**Proposed Temporary Warehouse (excluding Dangerous Goods Godown) with Ancillary Facilities  
for a Period of 3 Years and Associated Filling of Land in "Agriculture" Zone,  
Various Lots in D.D. 107, Fung Kat Heung, Yuen Long, New Territories**

**(S.16 Planning Application No. A/YL-KTN/1031)**

**Responses-to-Comments**

DWG NO.	VER.
PLAN 1	001

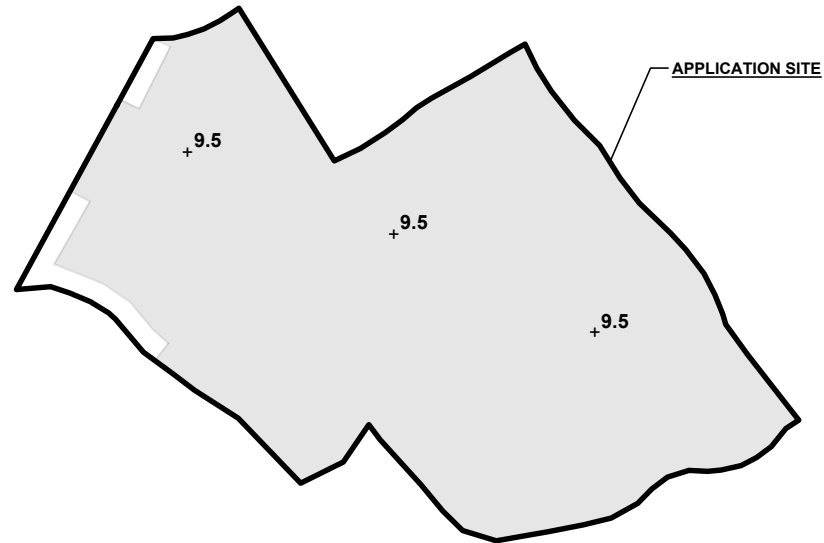
(a) Existing trees of common species are observed within the site. According to the land filling plan (Plan5), the proposed land filling is in conflict with the existing trees. With no tree information, proposed tree treatment, mitigation measure provided in the application, potential impact on the existing landscape resources within the site arising from the proposed use could not be reasonably ascertained.	According to the tree survey conducted on 30/08/2024, a total of <u>12</u> nos. of trees are recorded within the Site ( <b>Annex II</b> ). No old and valuable tree or protected species has been identified in accordance with DEVB TC(W) No. 5/2020 – Registration and Preservation of Old and Valuable Trees and the Forests and Countryside Ordinance (Cap. 96). Due to the proposed hard-paving works for site formation of structures and circulation purposes, all existing trees will be affected, and it is not proposed to retain any of the existing trees within the Site.

- (i) A revised plan showing the filling of land of the application site (the Site) is provided (**Plan 1** and **Annex I**). About 791m<sup>2</sup> (i.e. 31%) of the Site has already been hard-paved. All the existing hard-paved area will be removed by the applicant after planning approval has been obtained from the Town Planning Board (the Board). Majority of the Site (i.e. 2,517m<sup>2</sup>, 97%) is proposed to be filled with concrete of not more than 0.6m in depth for site formation of structure and circulation space. The remaining area will remain as soiled ground for healthy tree growth.
- (ii) A RtoC Table:

DWG. TITLE  
 LANDSCAPE PROPOSAL

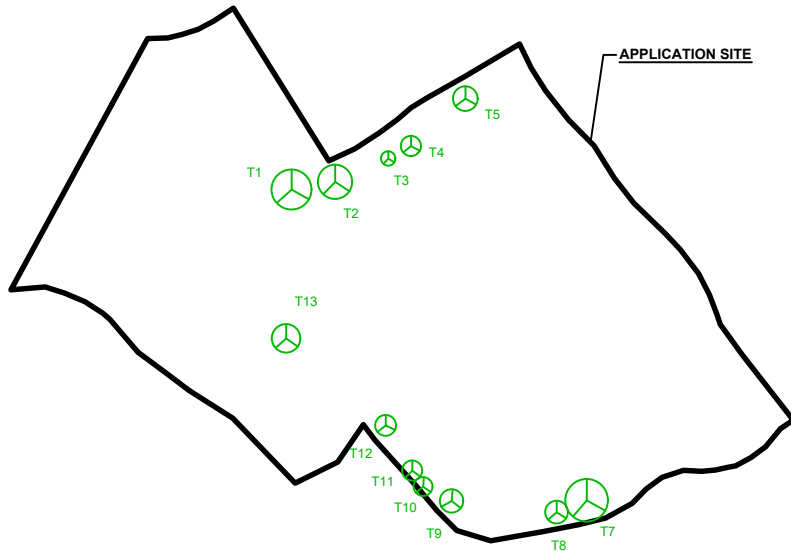
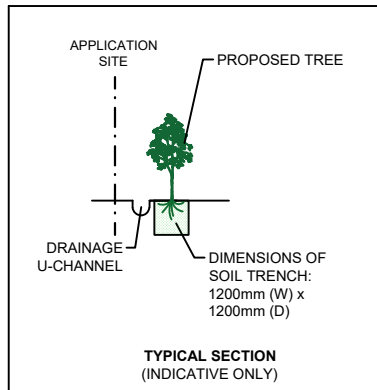
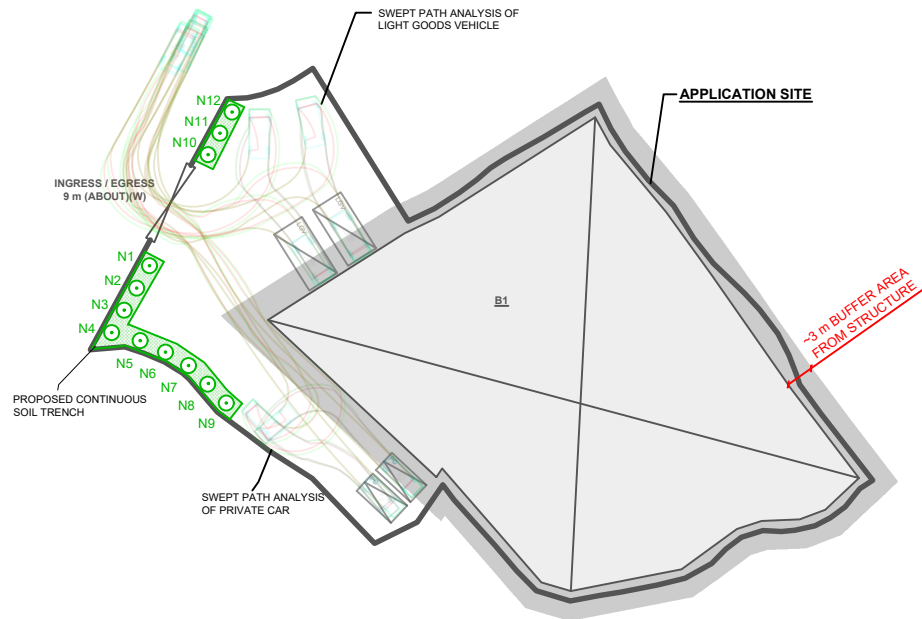
(b) The applicant is advised to provide information on the existing trees within the application site including location, species and sizes, general condition with photos, proposed tree treatment and mitigation measures for consideration.	Due to the felling of existing trees within the Site. A landscape proposal is submitted by the applicant to provide landscape mitigation measures for the proposed development ( <b>Annex III</b> ). <u>12</u> new trees (N1 to N12), with continuous soil trench, are proposed to be planted along the west and northwest periphery boundary of the Site as a landscape buffer to minimise adverse visual impact to the surrounding areas. All

these new trees within the Site will be maintained by the applicant during the planning approval period.
(c)	The applicant is advised that approval of the application does not imply approval of tree works, if any, such as pruning, transplanting and felling. The applicant is reminded to seek comments and approval for any proposed tree works from the relevant department prior to the commencement of the works.	Noted.
<b>2. Comments of the District Planning Officer/Fanling, Sheung Shui and Yuen Long East, Planning Department (DPO/FSYLE, PlanD)</b> <b>(Contact Person: Mr. David CHENG; Tel.: 3168 4046)</b>
